**CHARTER TOWNSHIP OF GARFIELD
PLANNING COMMISSION MEETING**

Charter Township of Garfield Planning Department Report No. 2025-1			
Prepared:	January 2, 2025	Pages:	2
Meeting:	January 14, 2025 Township Board	Attachments:	<input type="checkbox"/>
Subject:	Planning Department Monthly Report – January 2025

Charter Township of Garfield Planning Department Report No. 2025-2			
Prepared:	January 2, 2025	Pages:	8
Meeting:	January 8, 2025 Planning Commission	Attachments:	<input checked="" type="checkbox"/>
Subject:	TowerNorth Wireless Communication Facility Special Use Permit – Public Hearing		
File No.	SUP-2024-02	Parcel No.	05-019-001-00 (part)
Applicant:	TowerNorth Development, LLC		
Agent:	Jaime Mathew w/Kimley-Horn and Associates, Inc.		
Owner:	Frank A Bare

**SITE PLAN
 DETAIL**

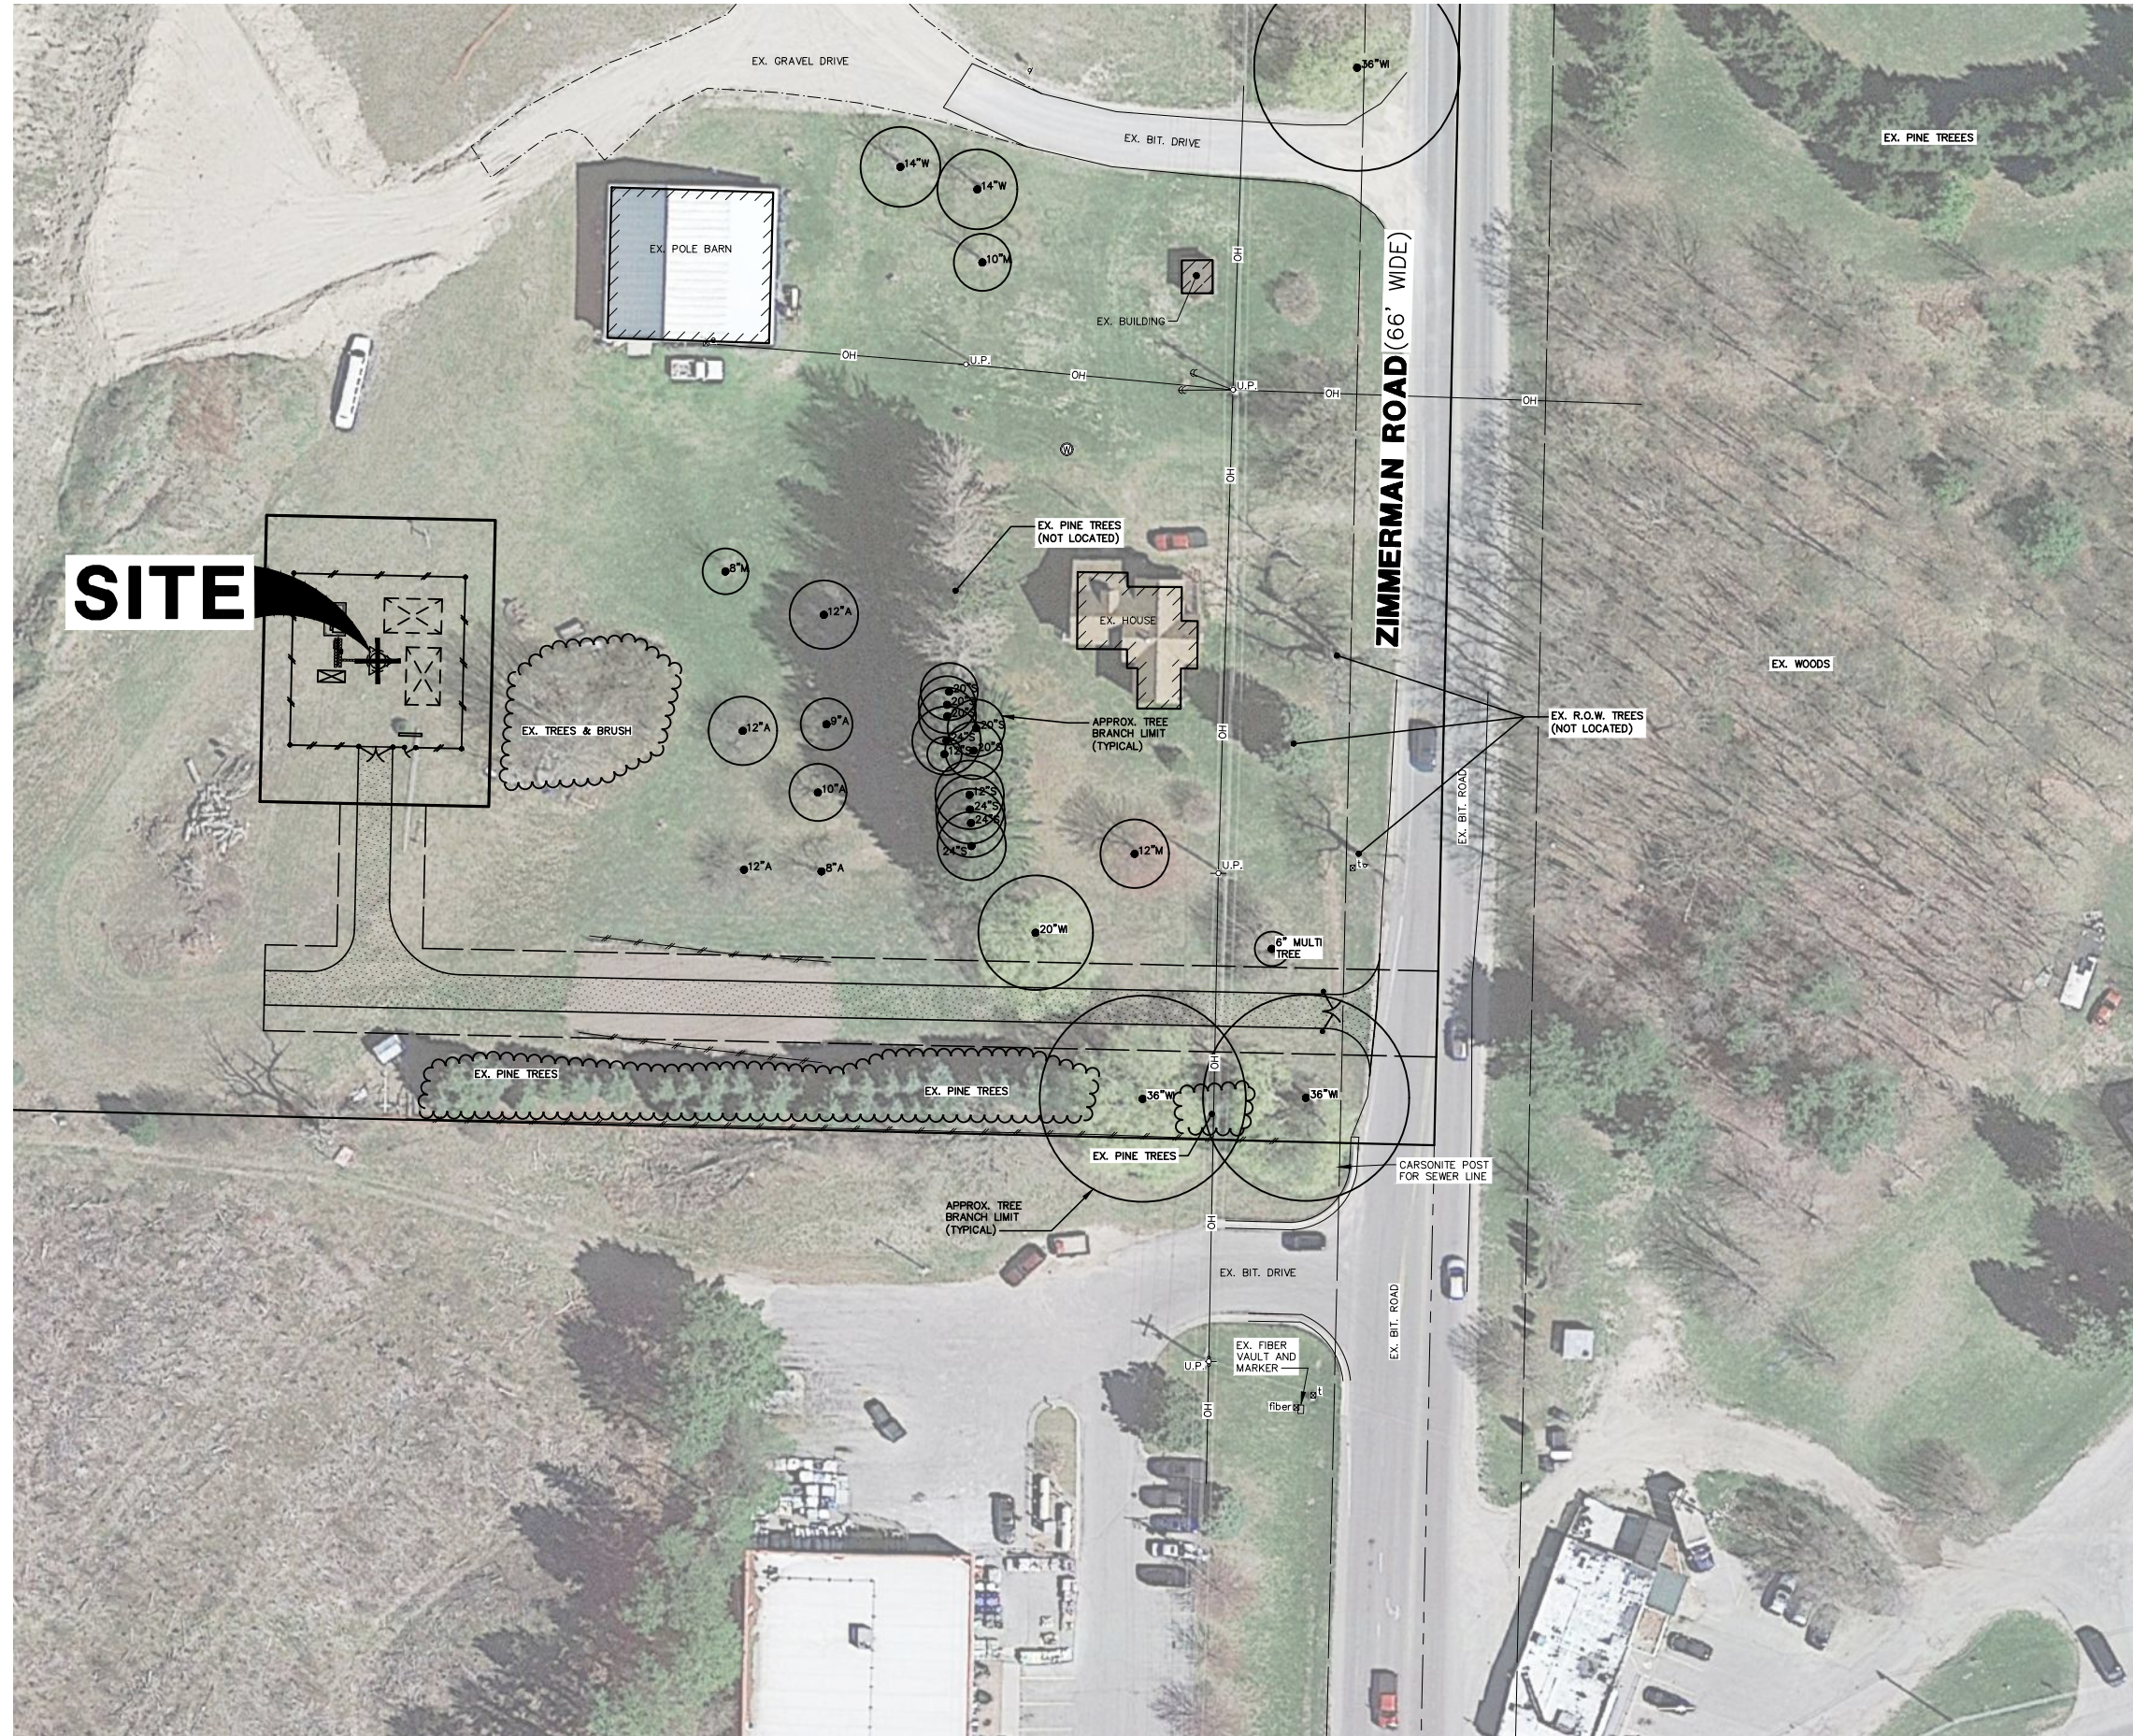
The cover letter notes the ground equipment will be less than 15 feet in height. The updated site plans need to show an elevation sketch of the ground equipment and shelter.

The updated site plan shows a 60' x 60' fenced-in area with a 6'-high chain link fence and indicates that there will be a 12-foot-wide double leaf gate and a 4-foot-wide swing gate for the fenced area. There is also a proposed entrance gate for the drive leading up to the leased area, details of which are shown on the site plan.

SE2.1

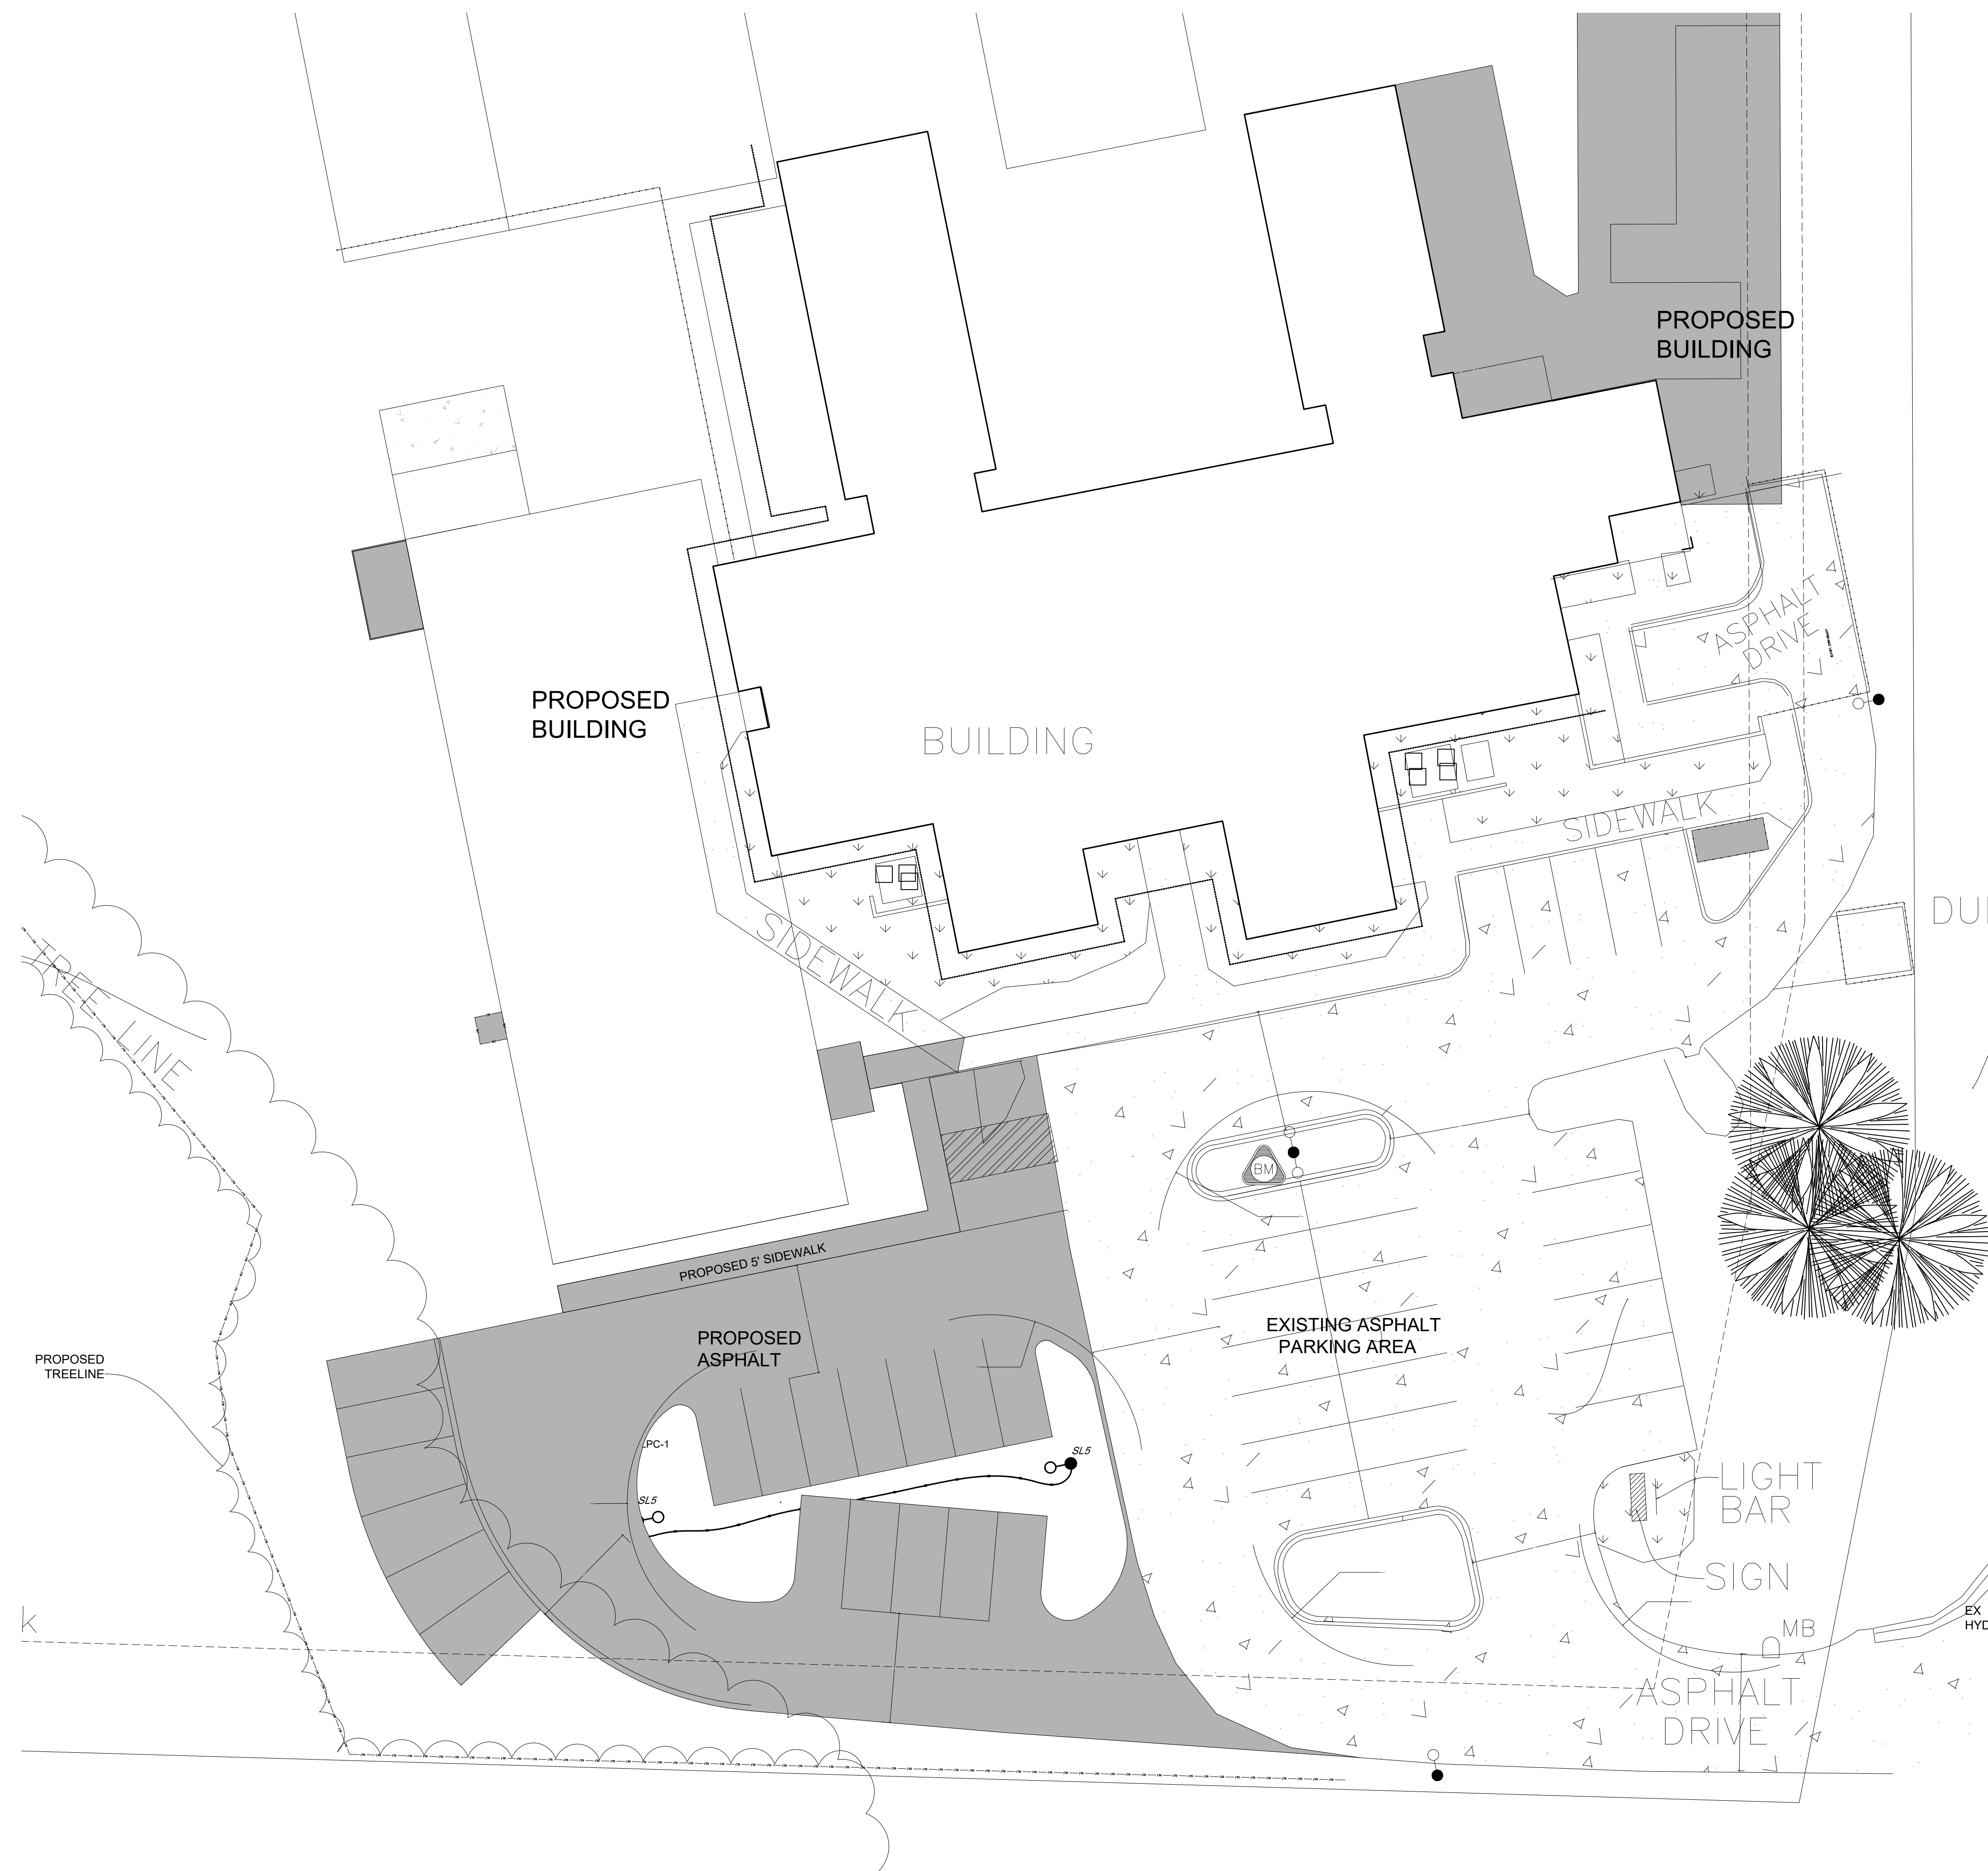
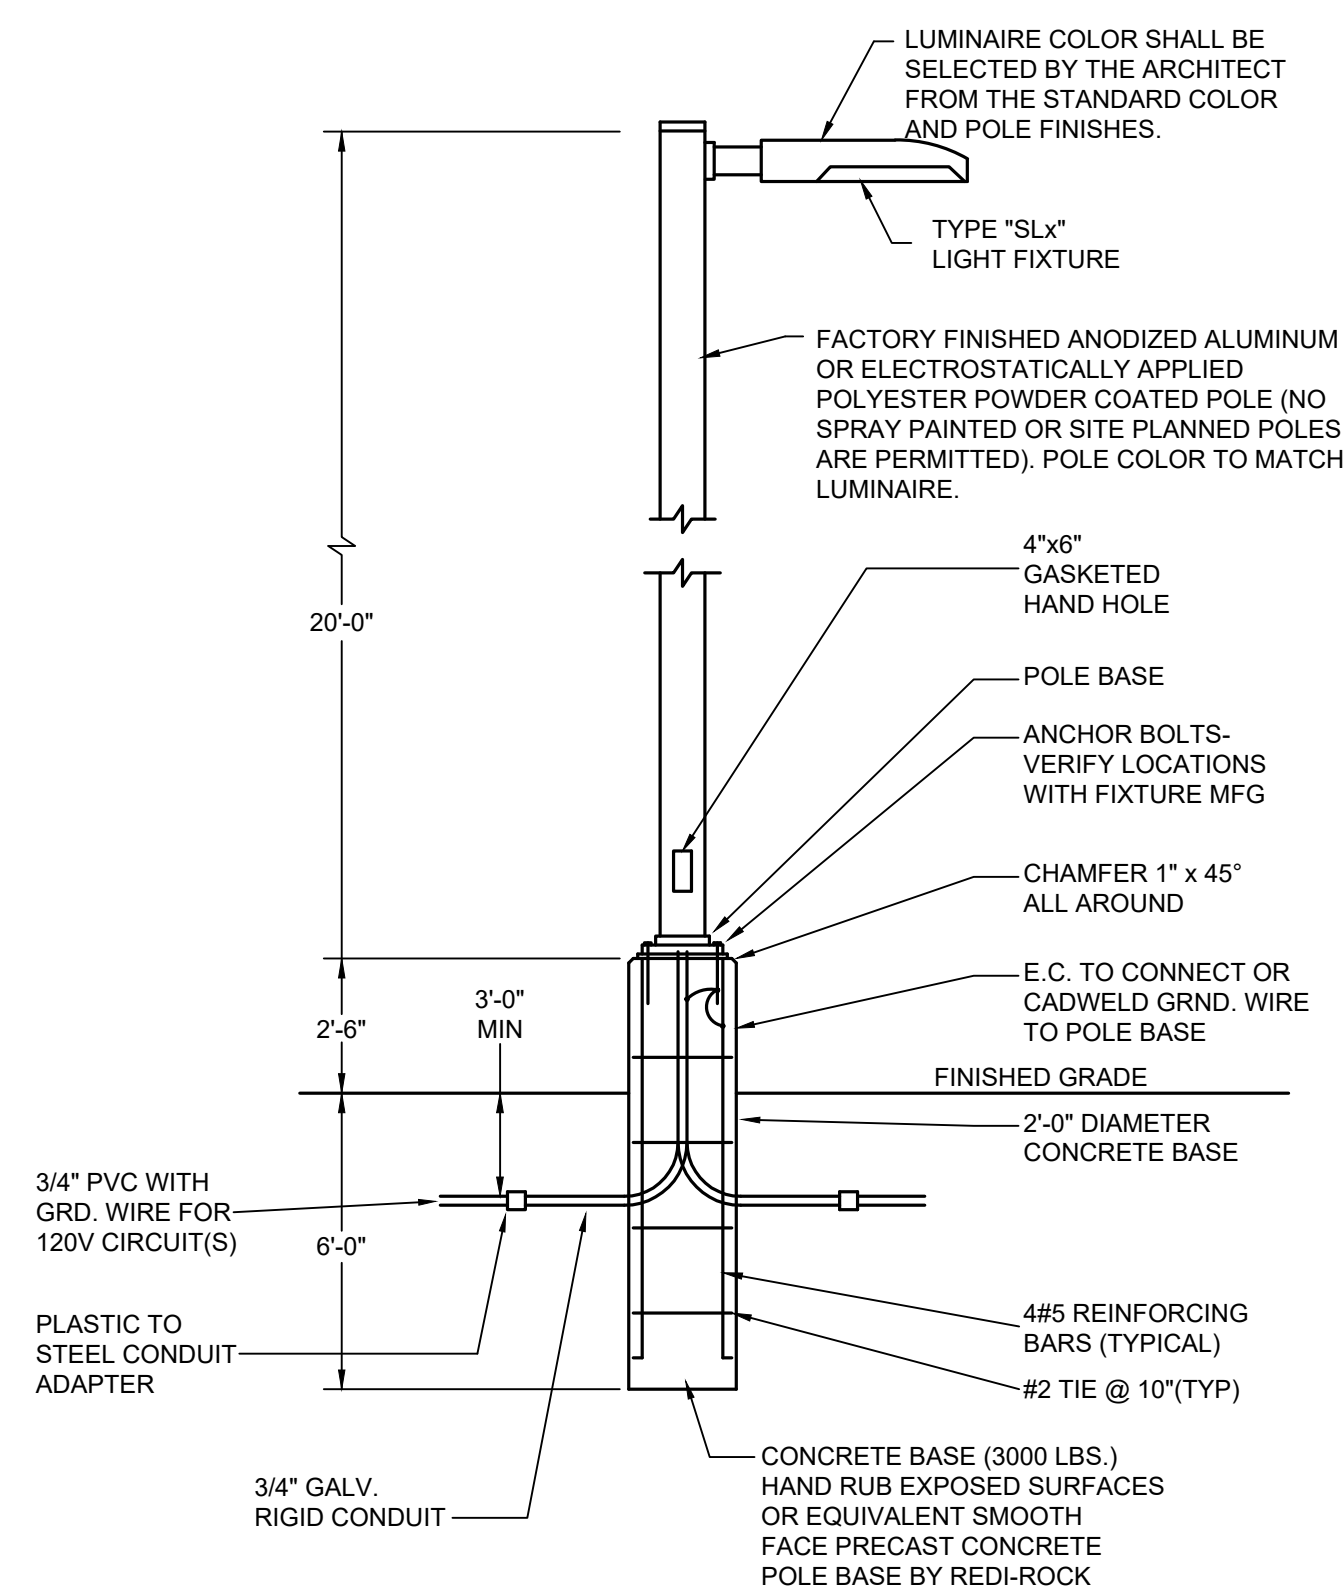
The site plan set includes an Electrical Site Plan (Sheet SE2.1) and Site Lighting Photometrics (Sheet SLC) to demonstrate site lighting. The applicant has also submitted a cut sheet of the proposed lighting fixtures. These site plan sheets, and the cut sheet of the proposed lighting fixtures, are both attached to this report. The lighting standards of Section 517 of the Zoning Ordinance are described by the following:
